MITSUBISHI SERVICE PUBLICATIONS TRANSMITTAL

SN 162/32-021

Main Landing Gear Leg Fitting Lugs Detail Inspection

SUBJECT: Main Landing Gear Leg Fitting Lugs Detail Inspection

Figure 1: LH MLG Leg Fitting (P/N 030A-32315-1)

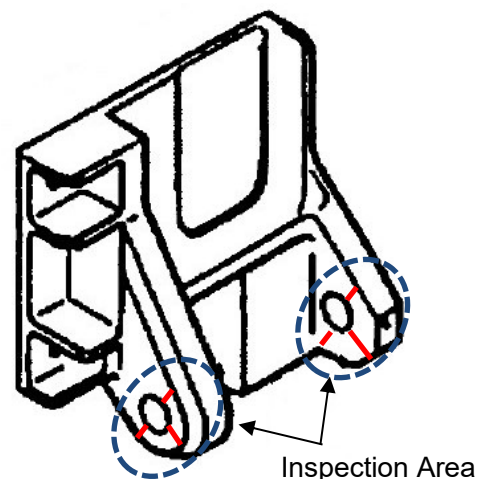
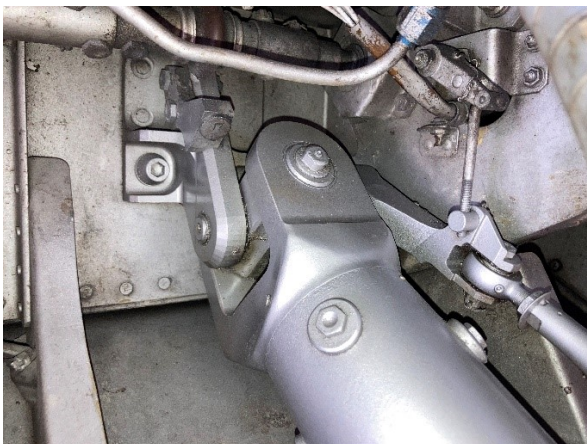
While a non-destructive inspection method is being prepared, MHI requests that each long body airplane owner and/or operator perform a detailed visual inspect and a dye penetrant inspection for any cracks in or around the lug portion of the fittings before the next flight and during the next periodic inspection. Areas to be inspected are indicated in Figure 1 below. Additional potential crack locations are highlighted. Also, it is important to apply lubrication to the fittings through grease ports in accordance with instructions in the applicable Maintenance Manuals.
